Track Control arm
BMW (E46)

21278 R

21279 R

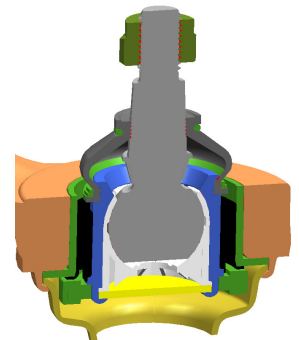
- Early wear of rubber bedding Ball Joint.
- Play on ball joint.

- Weak connection by rubber between inner and outer bushing.
- Damaged dustcover.

- A new ball joint is progressed without the rubber core.
- A cover is added to protect the pin and the dustcover during transport and storage.

! When the arm with rubber bedding is replaced by the improved version, replace both left and right arm !
